RESPONSE LETTER NO. 5 TO REQUEST FOR INFORMATION

Project Title: **South Dade Transit Operations Center (SD TOC)**
Project No.: **CIP227A-DTPW22-CT**

| BM-3A-SEL-230 | |

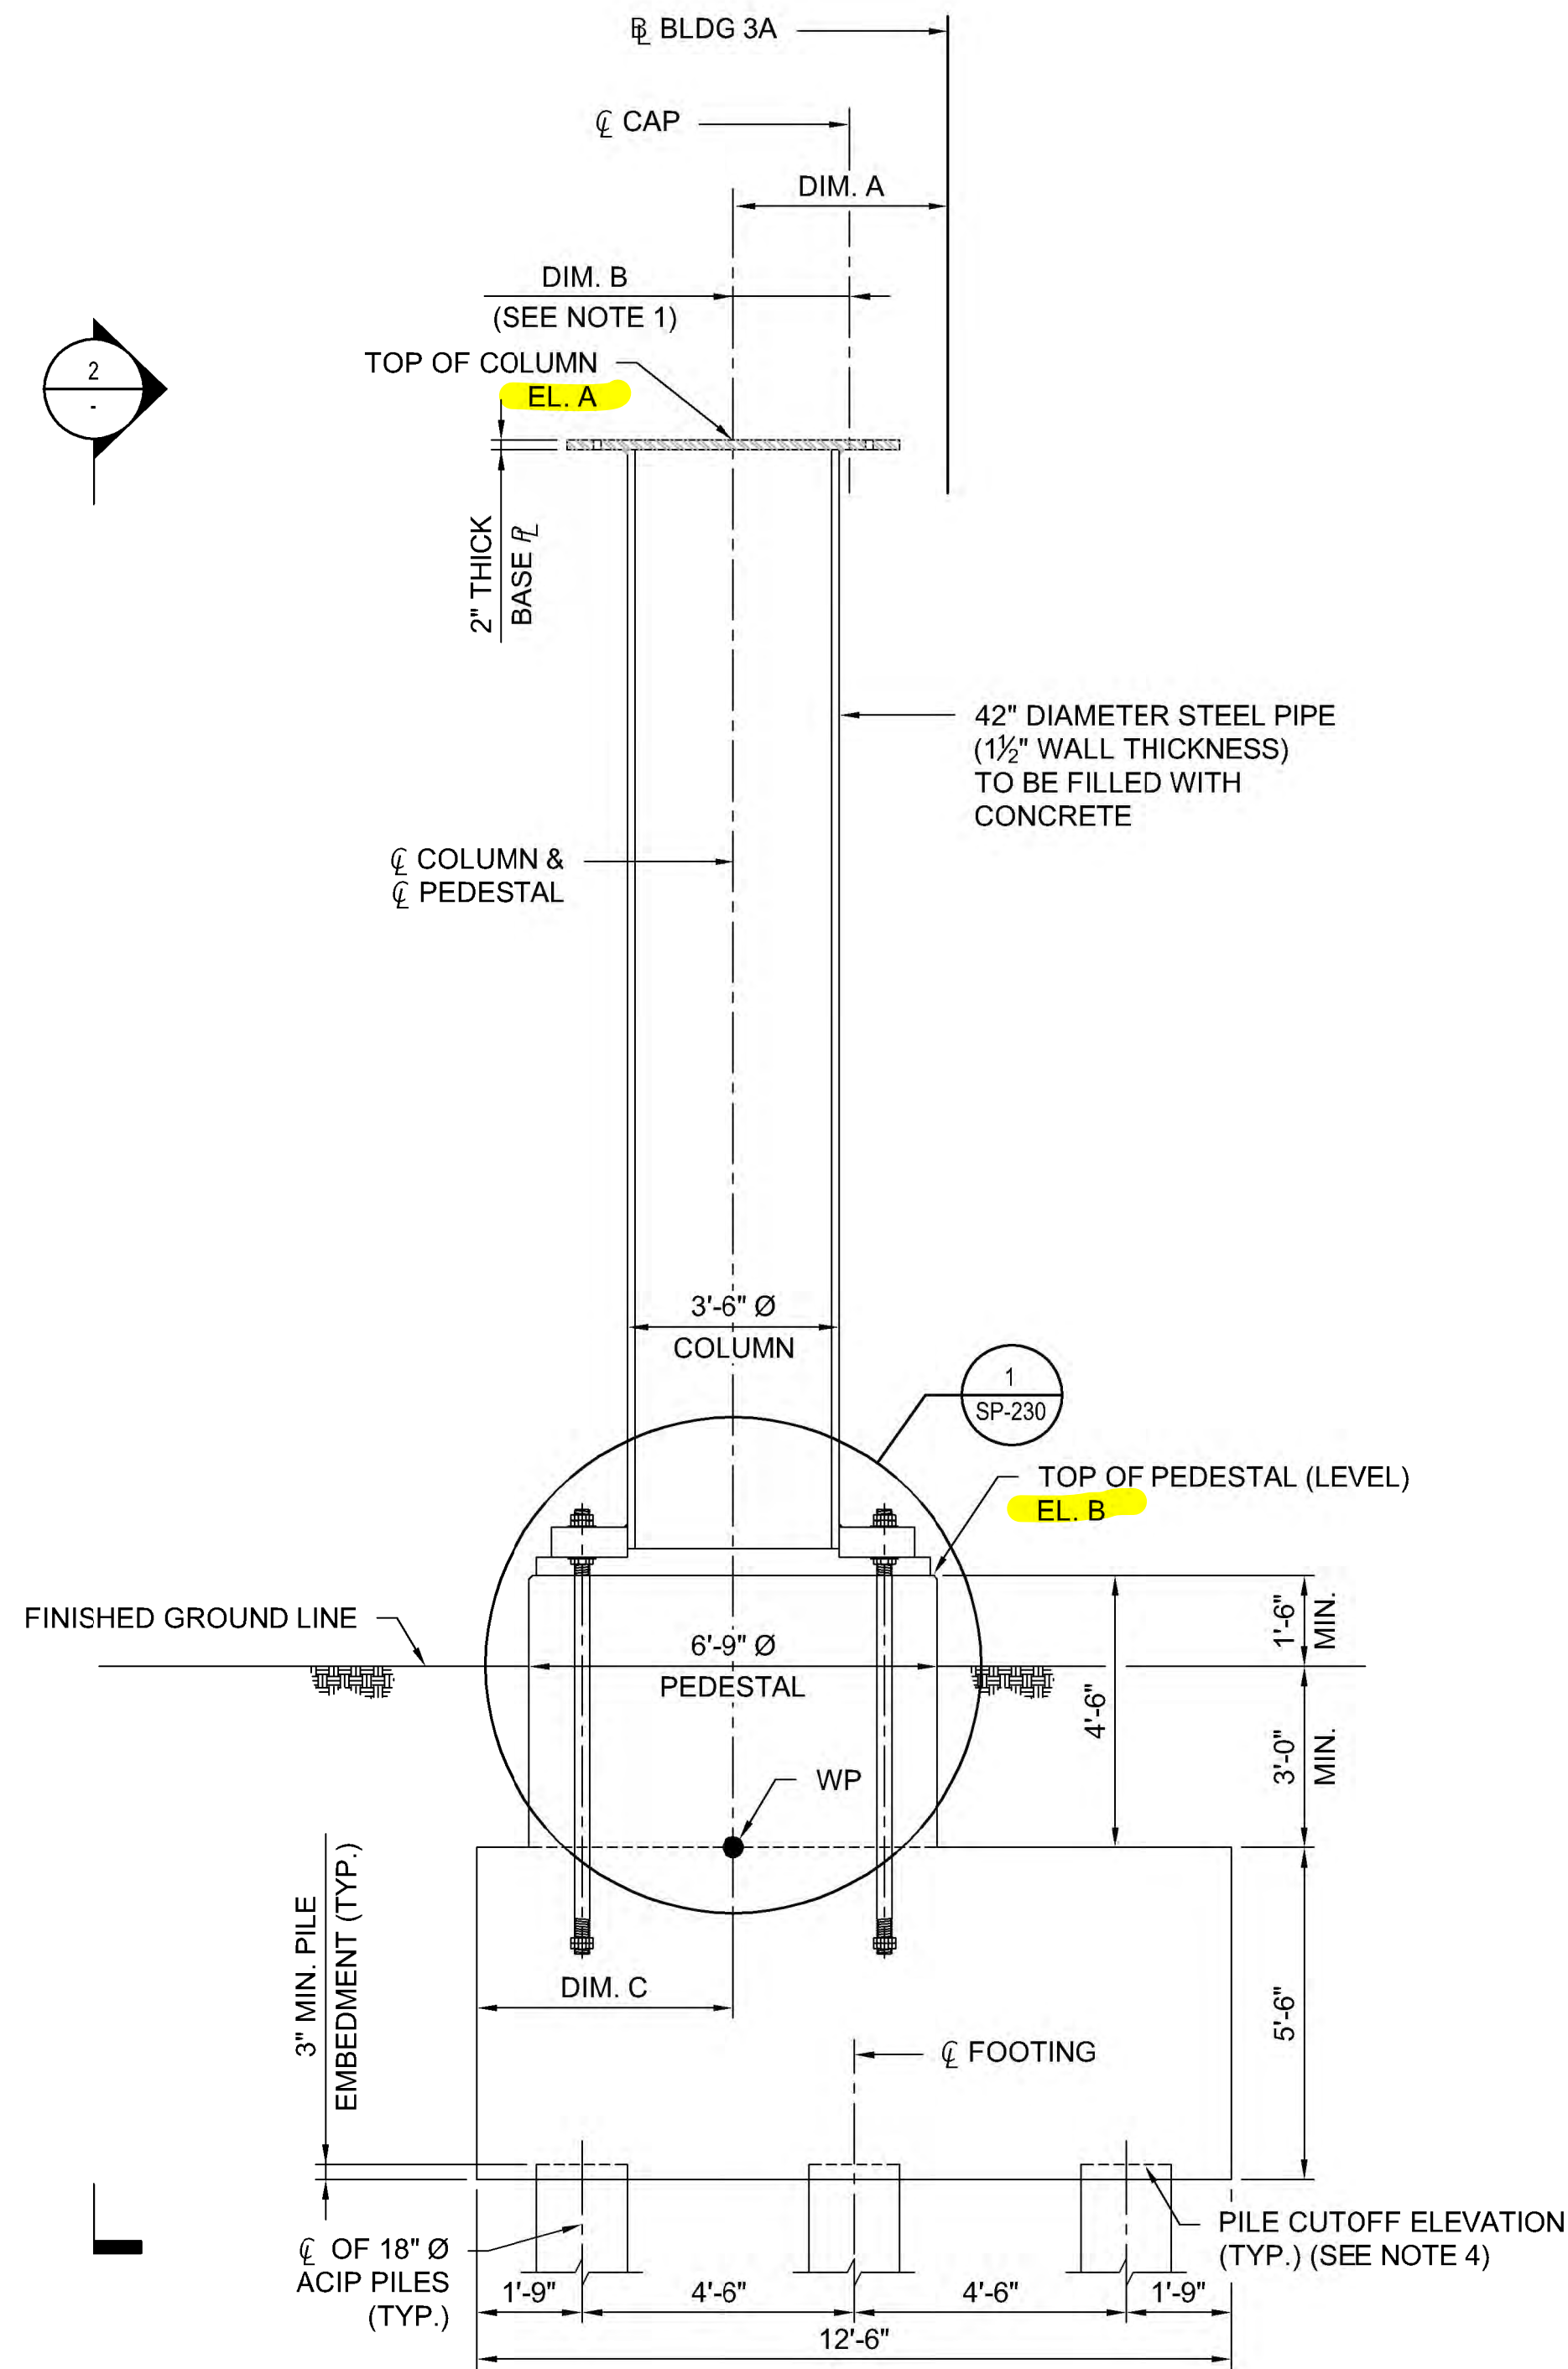
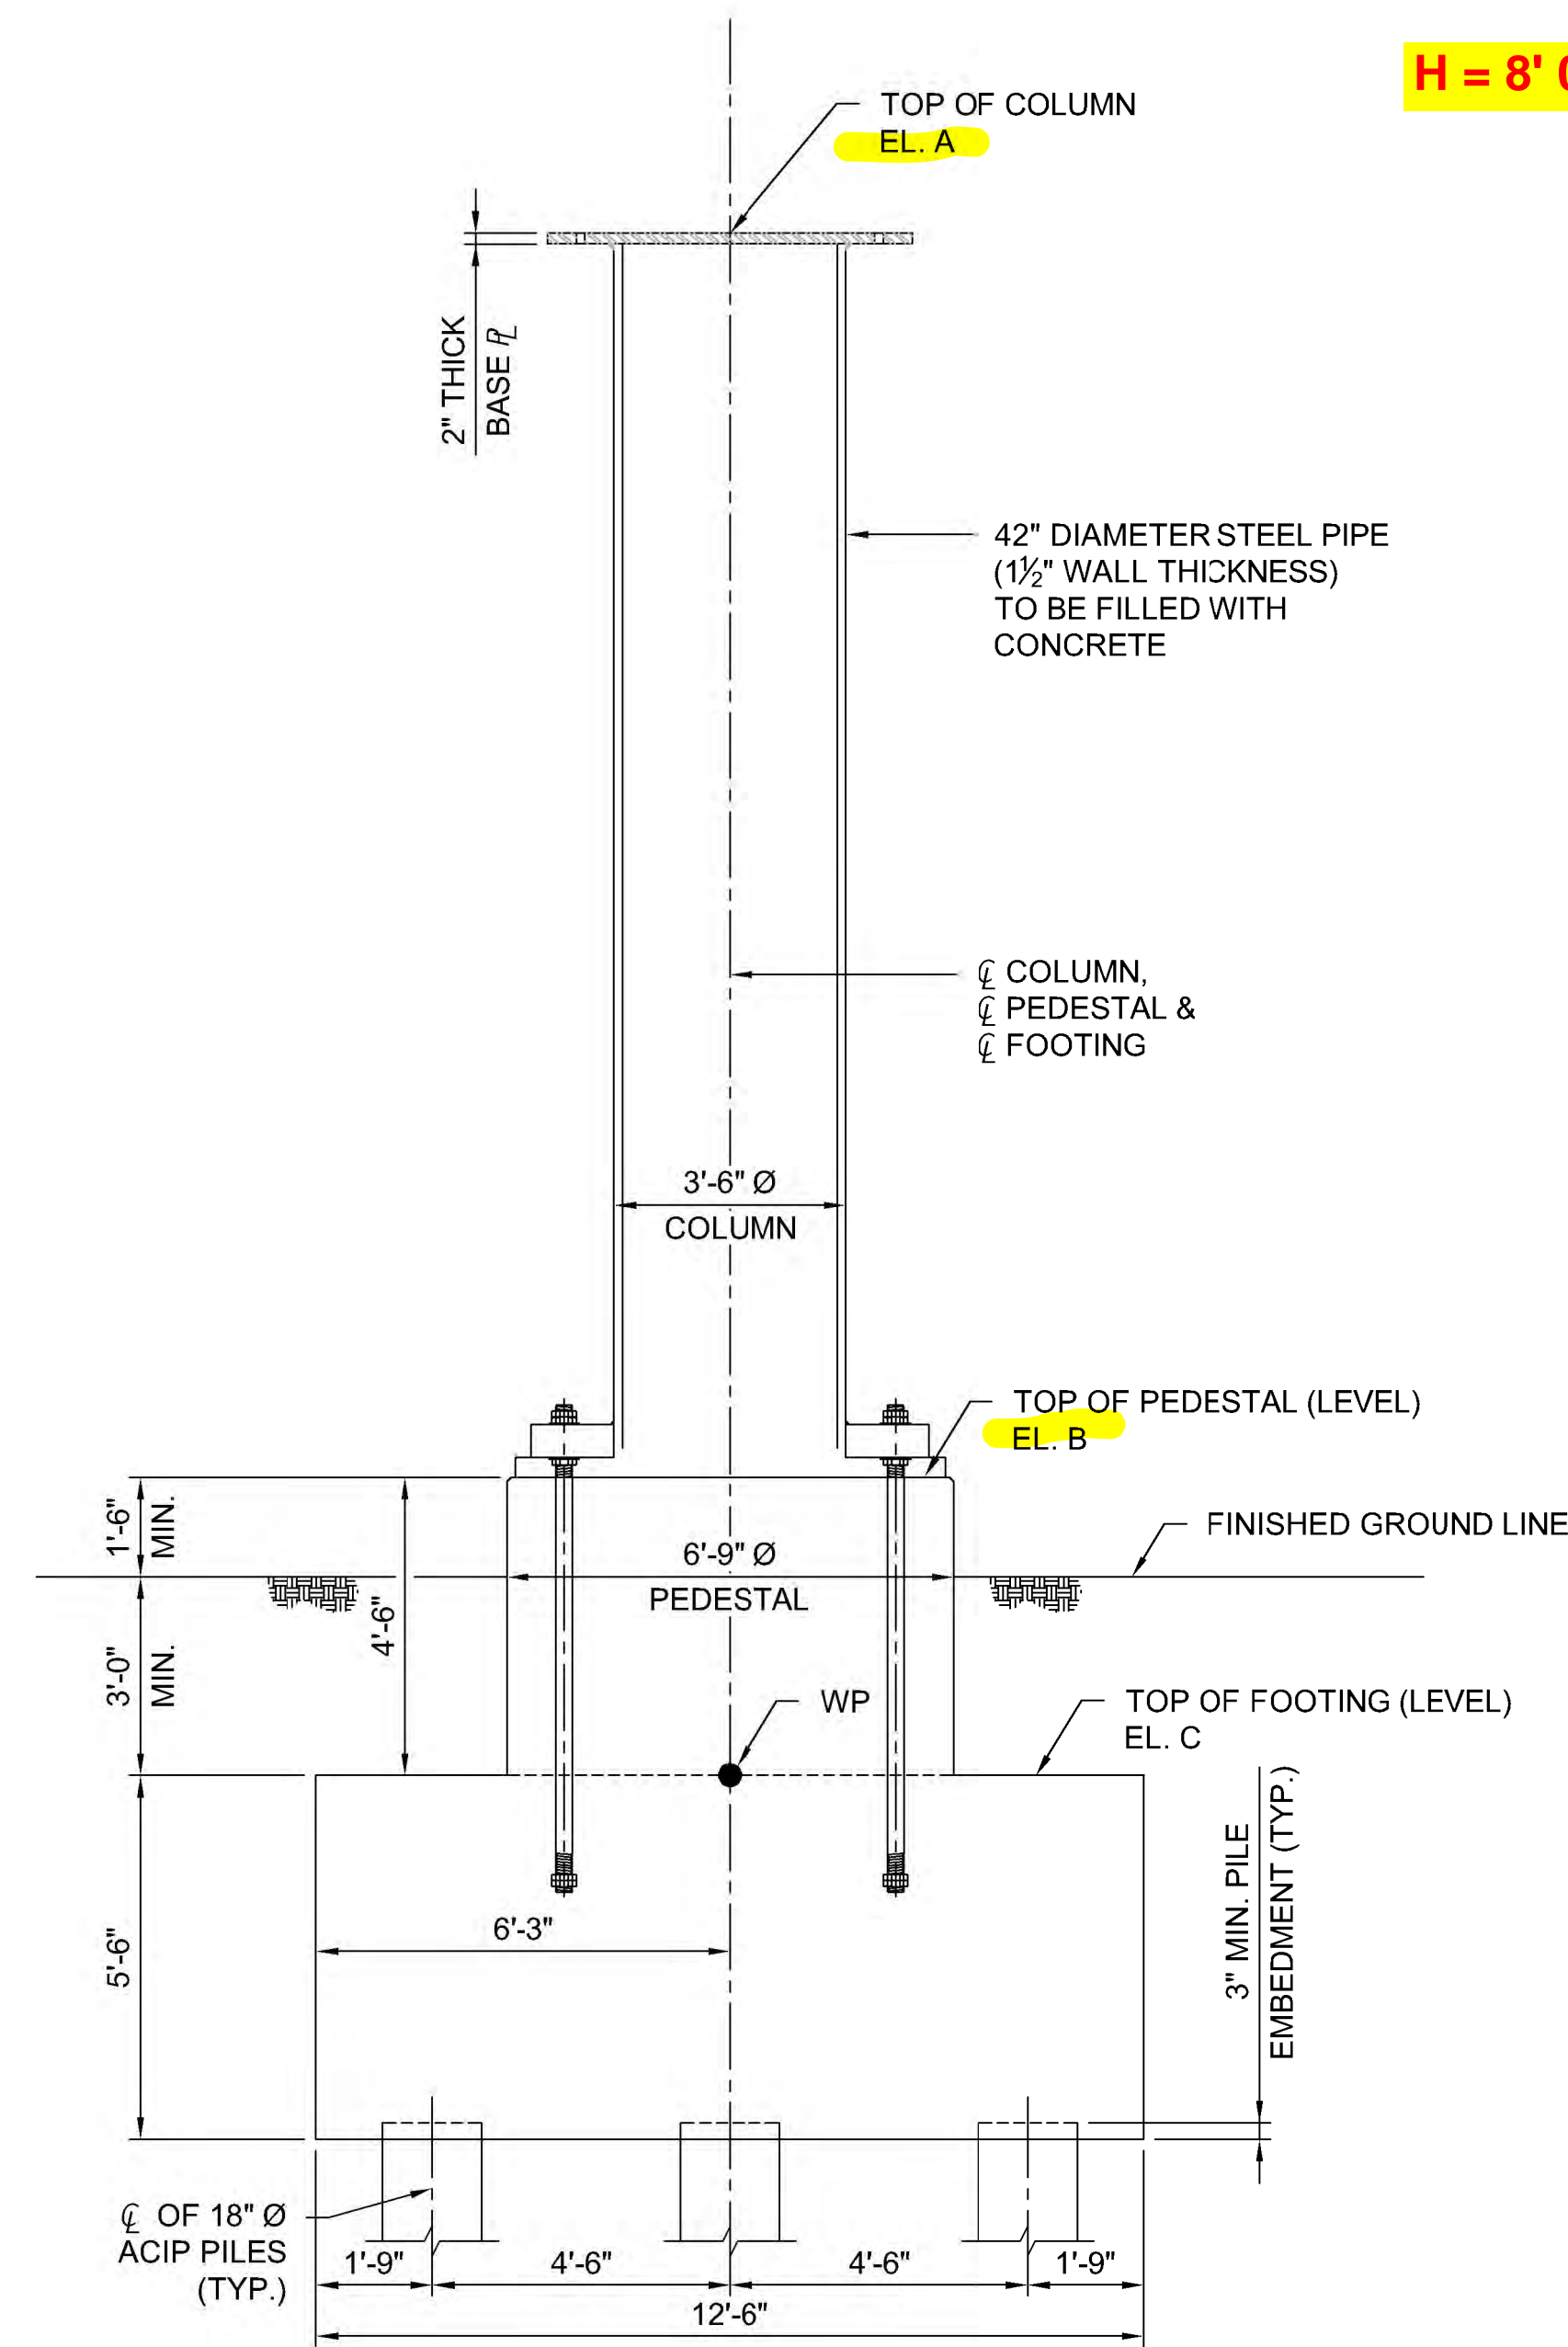
QUESTION No.2: Building 3A:
Discrepancy in height of 42" columns. See drawings BM-3A-SEL-224 (H ≈ 19') and BM-3A-SEL-230 (H = 8').
Confirm that 42" steel columns' thickness 1.5".

QUESTION No.2: **Building 3A:** Discrepancy in height of 42” columns. See drawings BM-3A-SEL-224 (H ≈ 19’) and BM-3A-SEL-230 (H =8’). Confirm that 42” steel columns’ thickness 1.5”. (See Plans attached to e-mail).

ANSWER No.2: Steel Column thickness of 1.5" is confirmed.
